Final Technical Plan
July 1988

LITIGATION TECHNICAL SUPPORT AND SERVICES

Rocky Mountain Arsenal

Offpost Remedial Investigation/Feasibility Study

Figure A-6
ORGANOSULFUR COMPOUNDS ASSESSMENT RMA
OFFPOST SECOND QUARTER SAMPLING OF WELLS
SOURCE: ESE, 1987

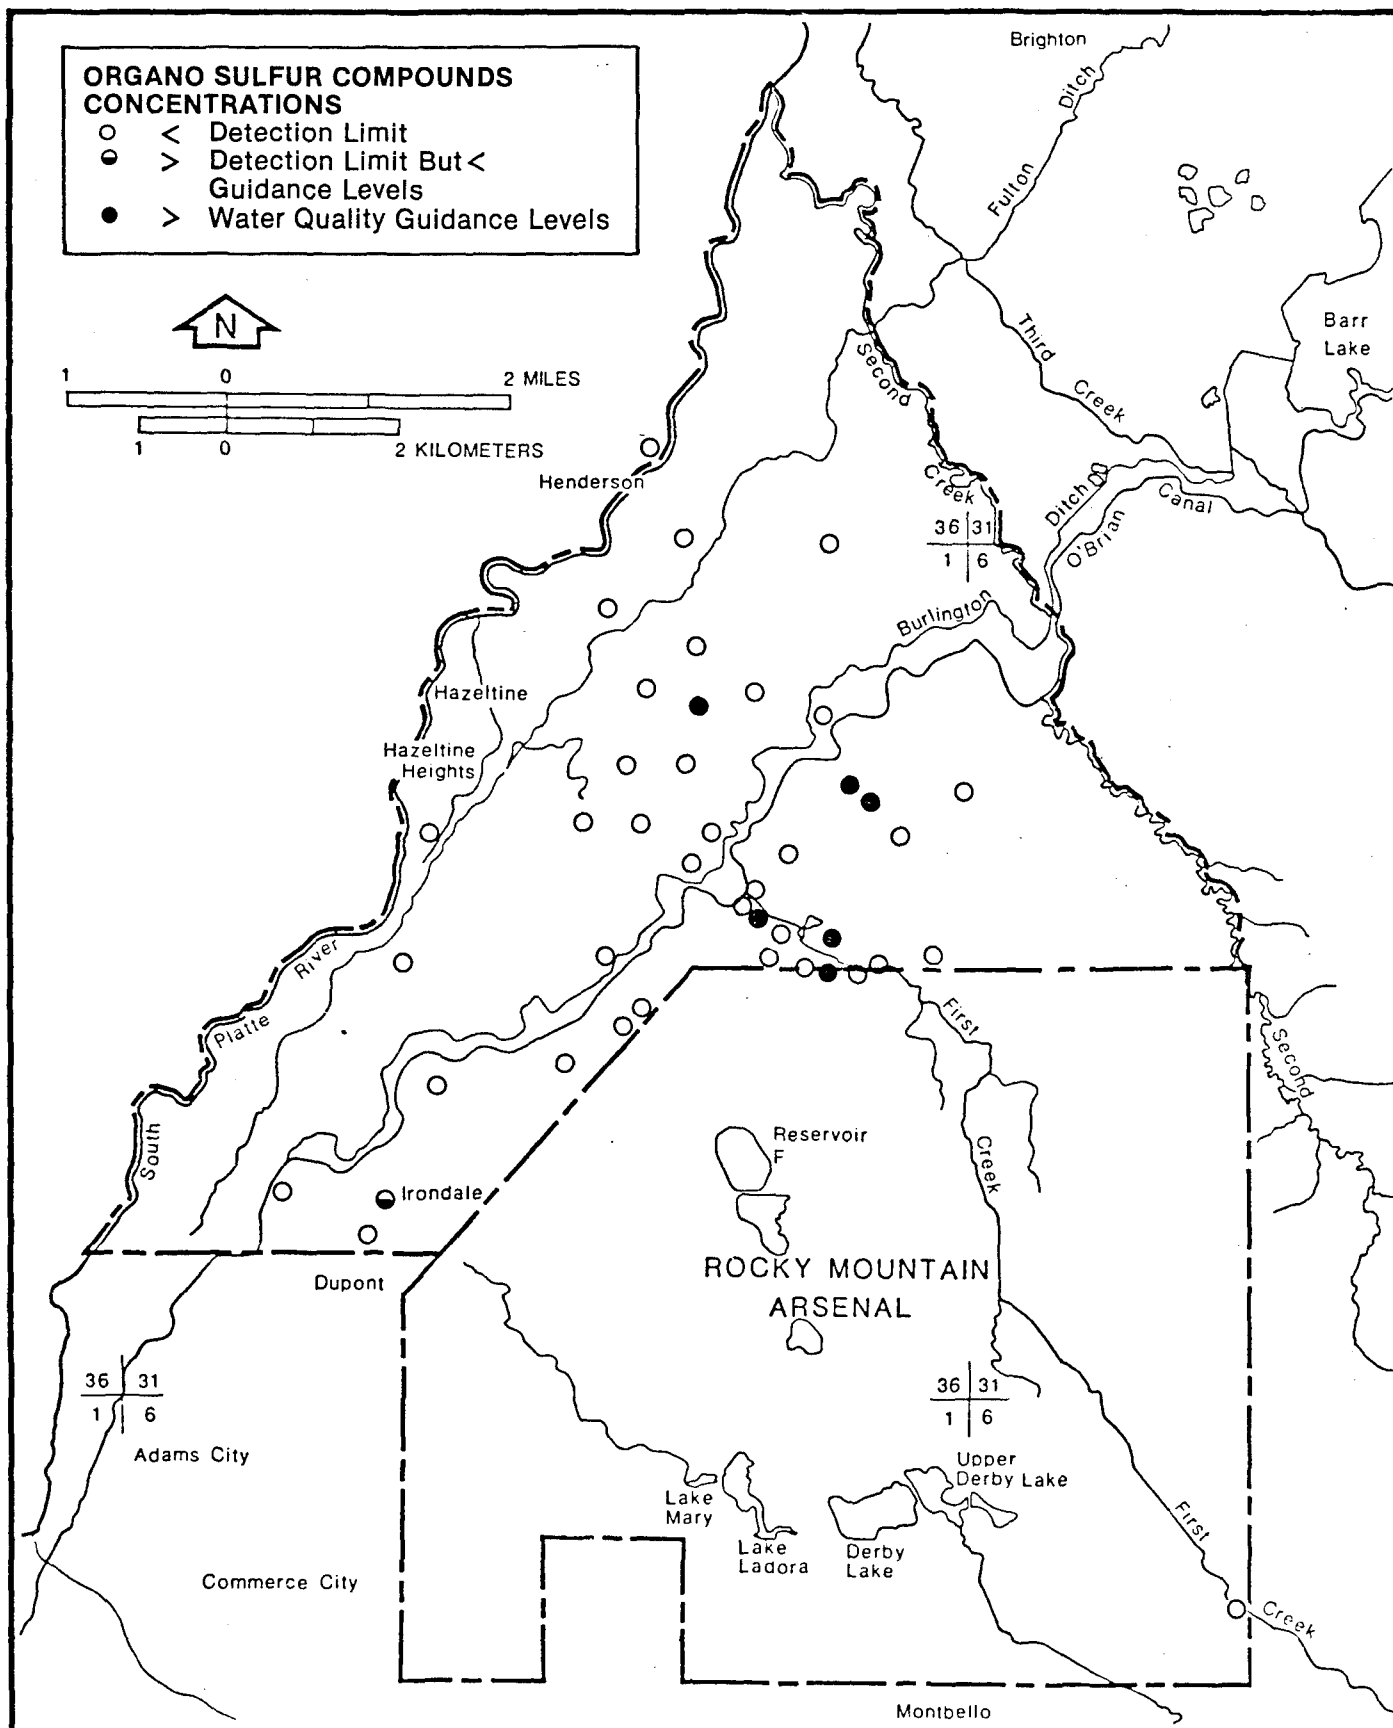
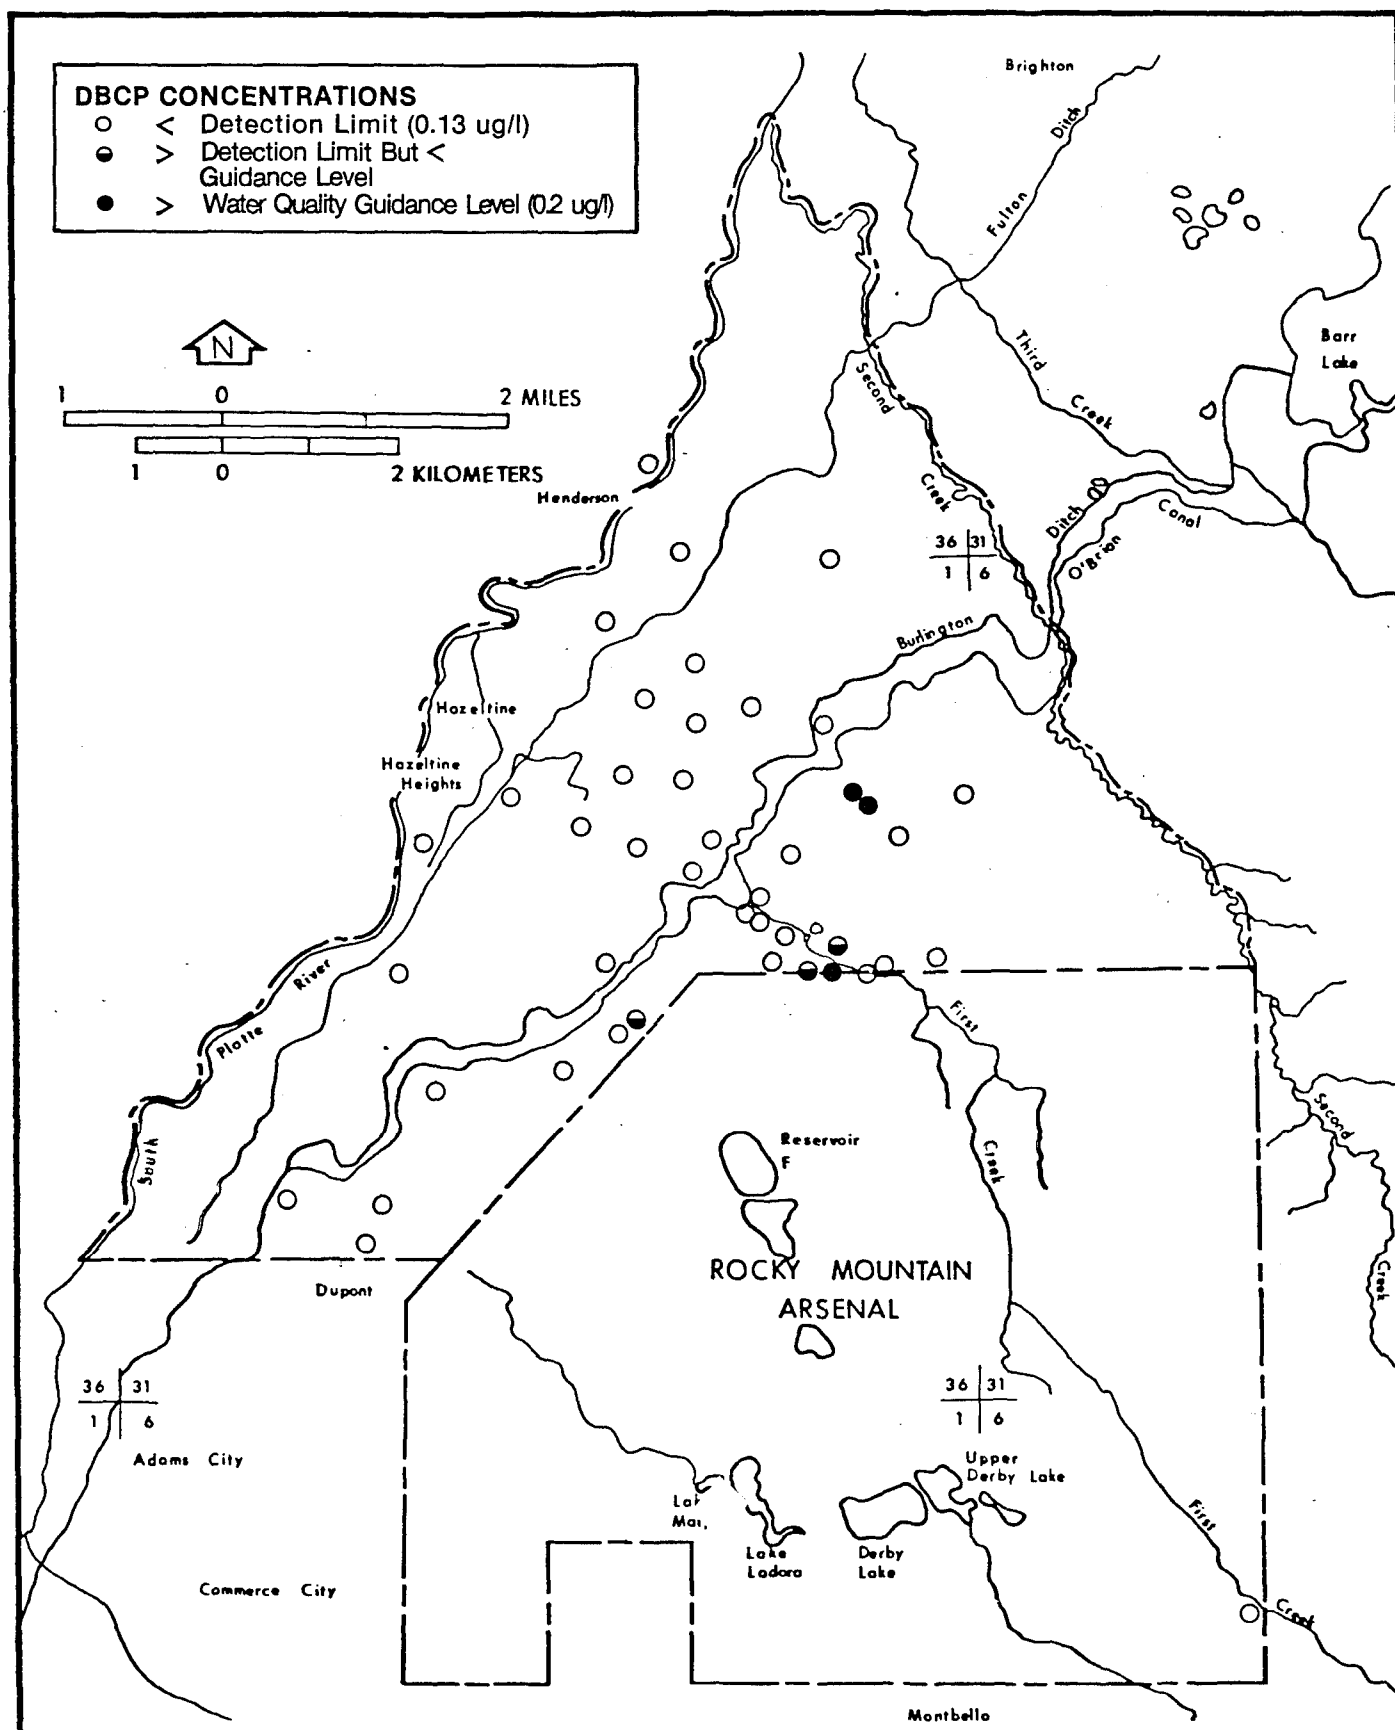
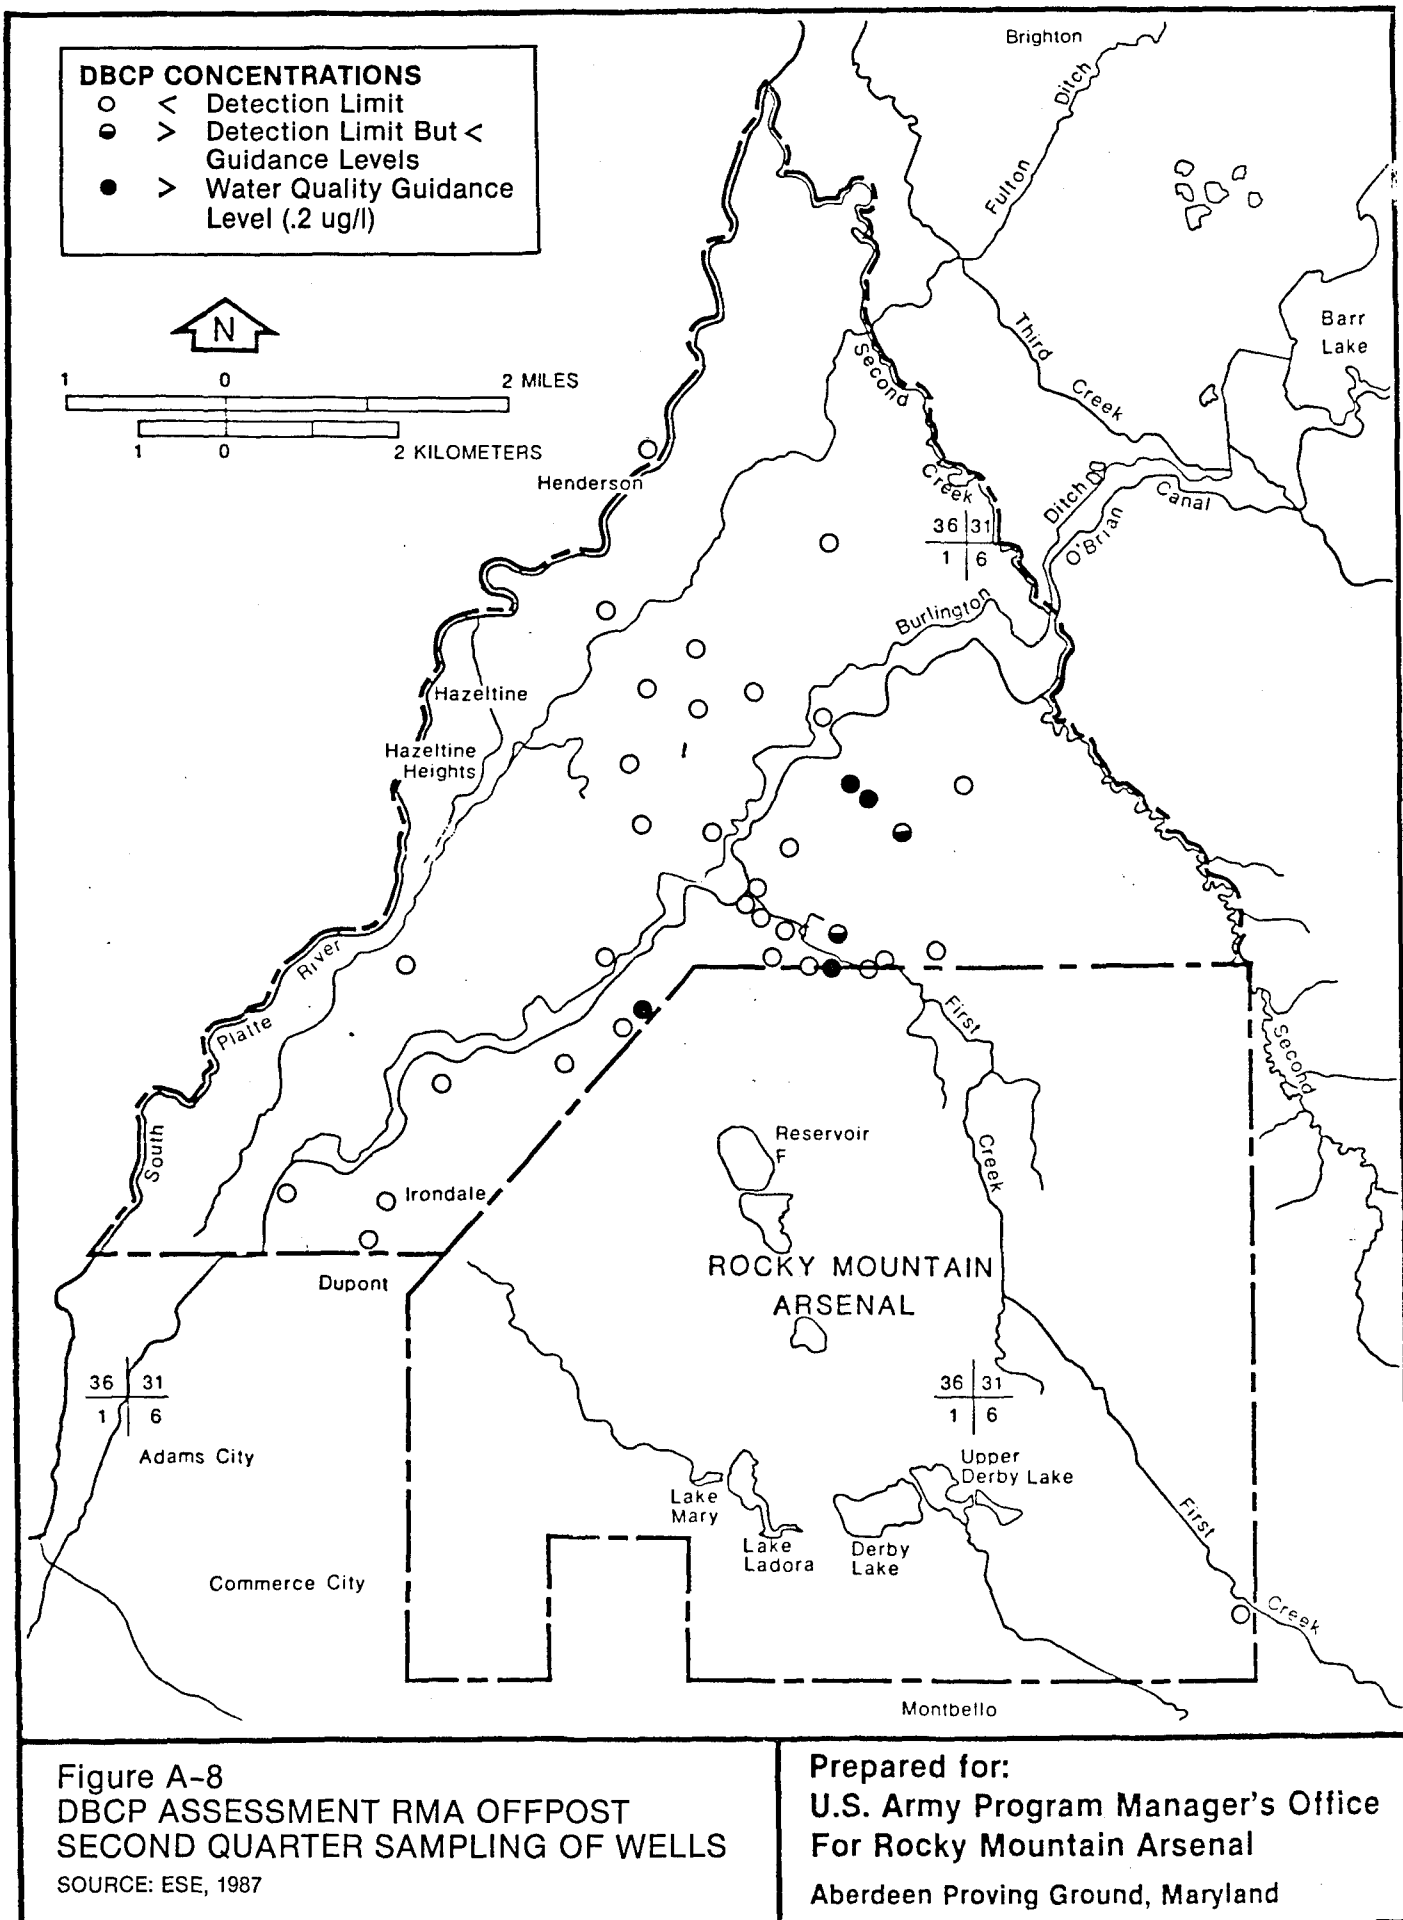
Comment 4:
Figure 1.4-1,
1.4-2, A-1 to A-9
